Our Ref: FS0728.LT.001

Grangewood School, Fore Street, Eastcote, Pinner HA5 2JQ

Local Planning Authority Reference: 2145/APP/2022/3543

Thank you for your comments regarding the above planning application. Please see our responses below regarding the proposed drainage condition 9 of your planning application response.

PROPOSED DRAINAGE STRATEGY

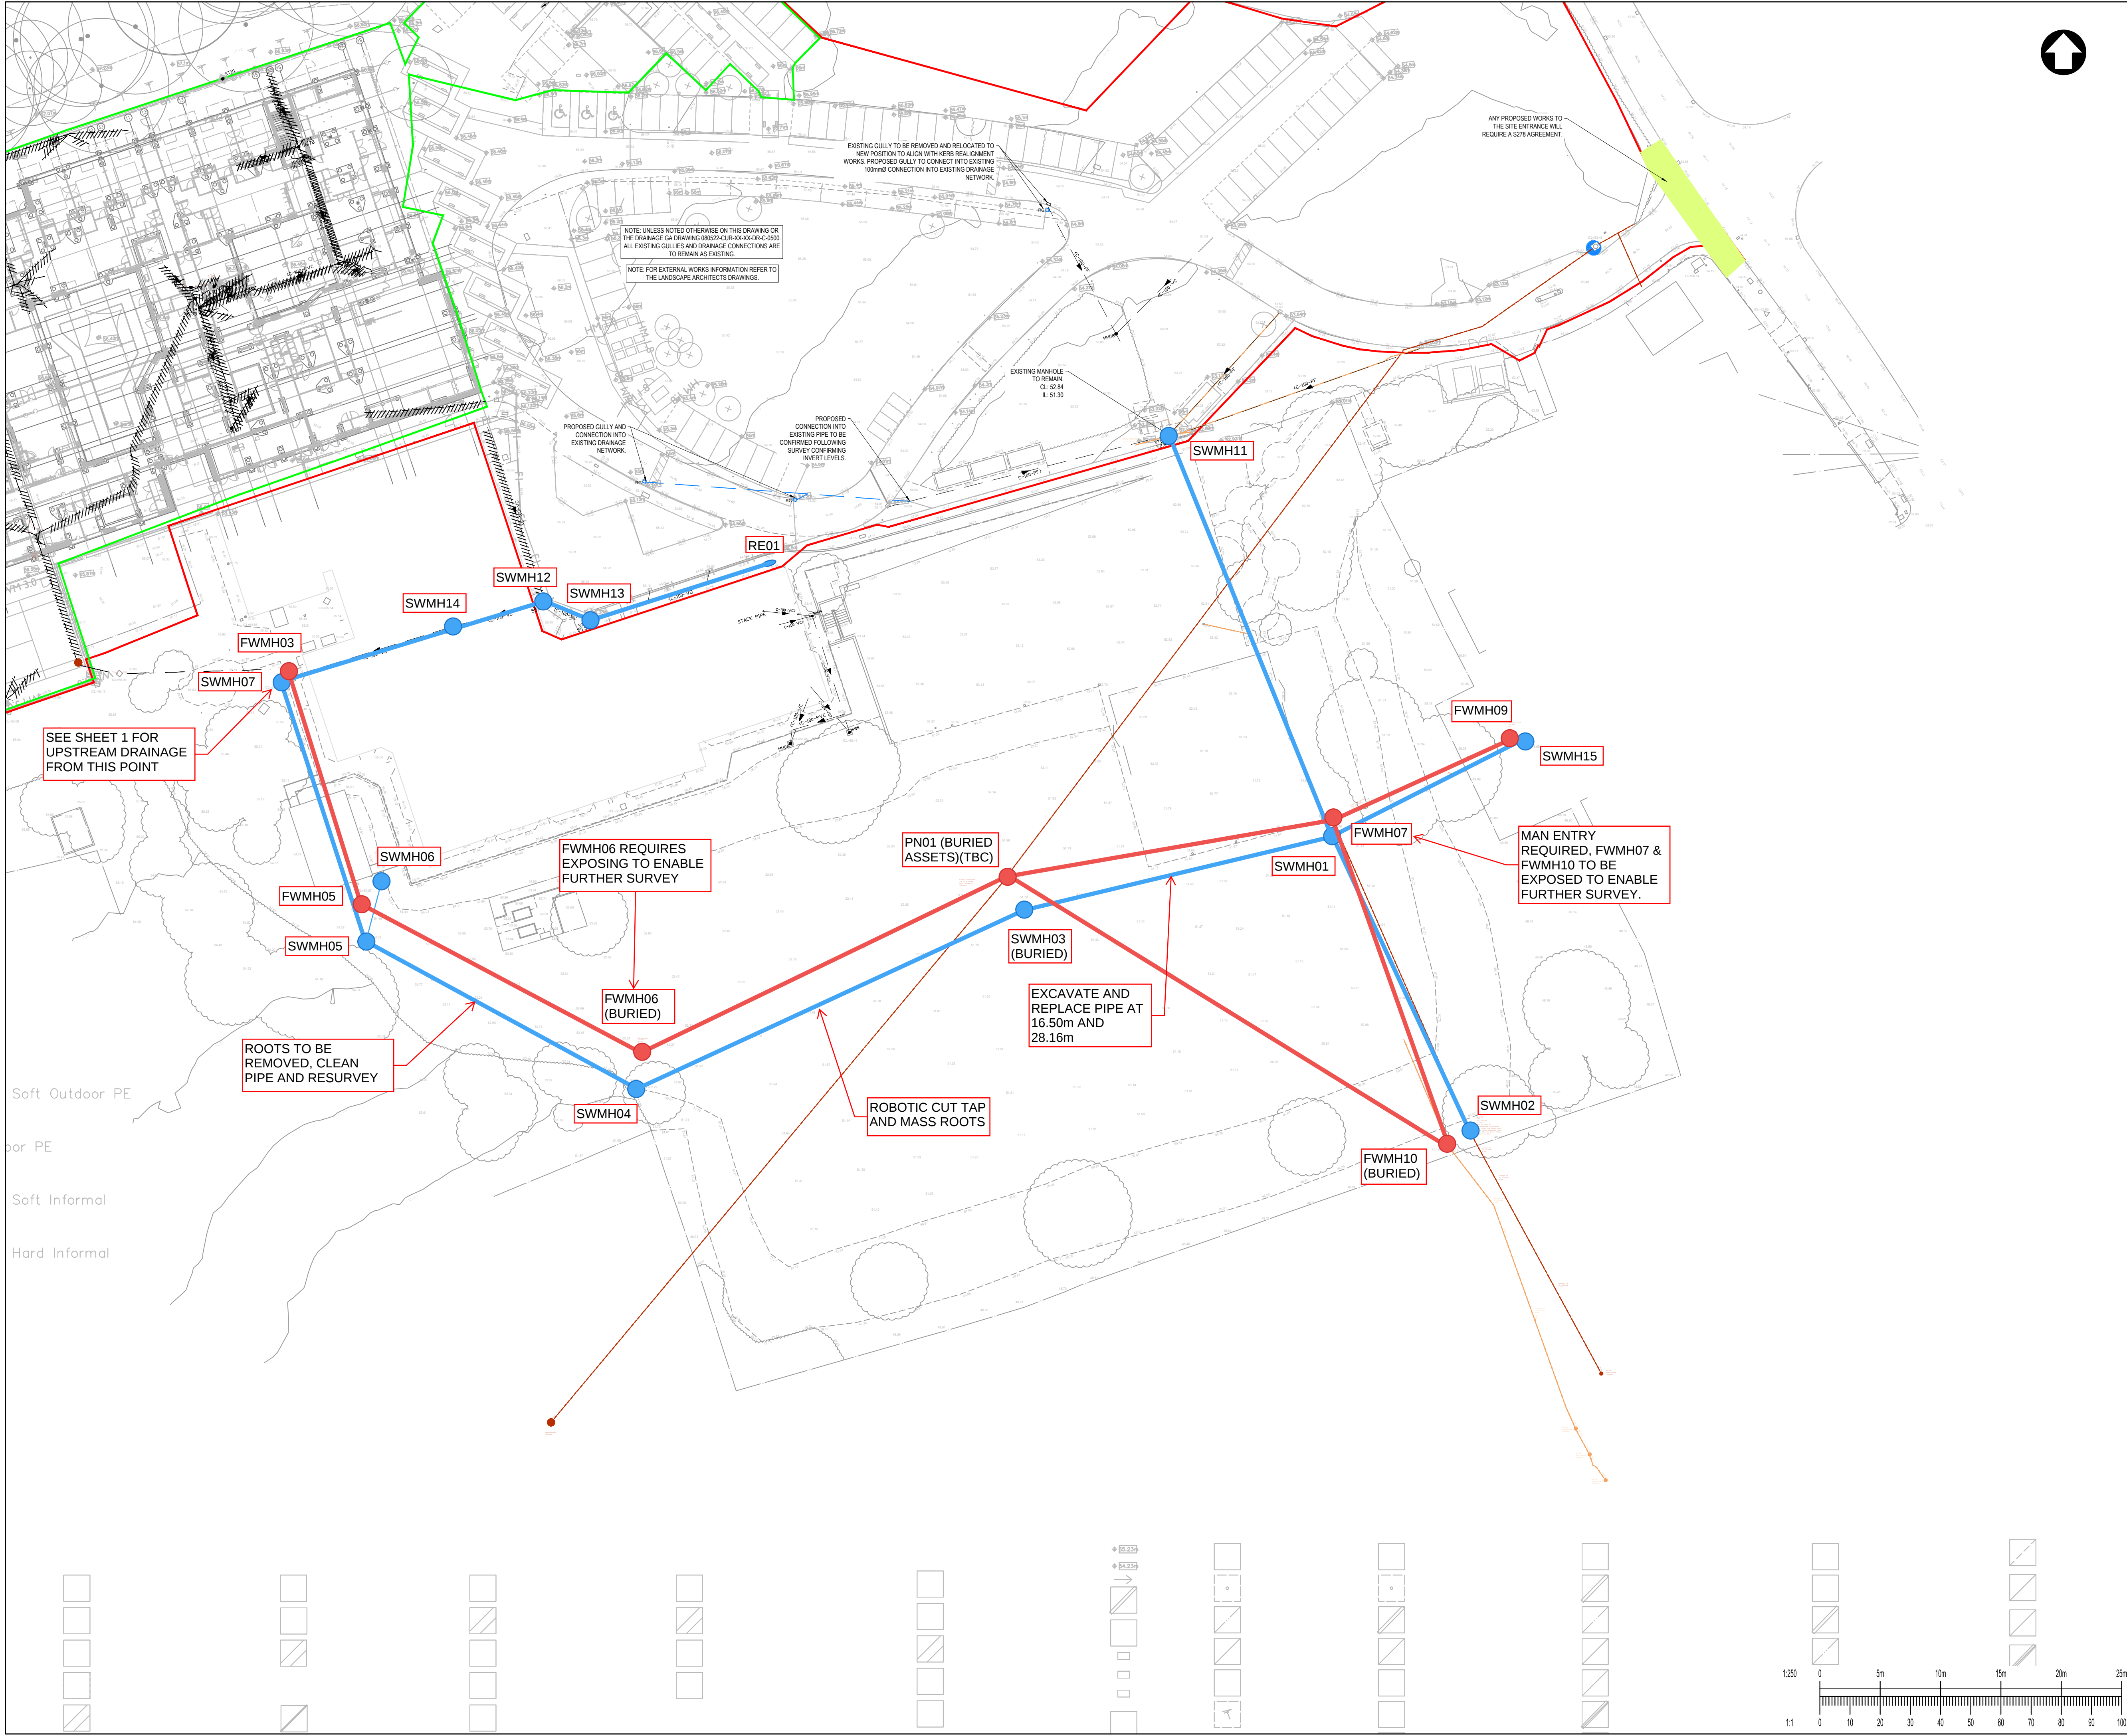
Comment a) i. *Surface water discharge - the submitted drainage strategy must confirm the proposed method and location of discharging collected surface water from the site in accordance with the hierarchy set out in the London Plan. Where the proposal does not utilise the most sustainable solution, justification must be provided. Any proposal that includes an off-site connection through a private sewer network should provide details of the condition and ownership of the entire drainage route to a public sewer or ordinary watercourse.*

It is proposed to connect into the existing private network currently serving the existing school building and the neighbouring school building. The existing network flows to the east of the site where it then connects into the nearby Thames Water sewer. The existing drainage has been CCTV surveyed to confirm the location and condition up to the connections to the Thames Water sewers. Following the CCTV survey it is proposed to retain and remediate the existing drainage as per the remediation plan sketches appended to this letter.

40 Seven CCTV Survey drainage mark up.
TO BE READ IN CONJUNCTURE WITH CCTV SURVEY INFORMATION DATED 01/06/23.

SURFACE WATER DRAINAGE TO BE REMEDIATED

FOUL WATER DRAINAGE TO BE REMEDIATED
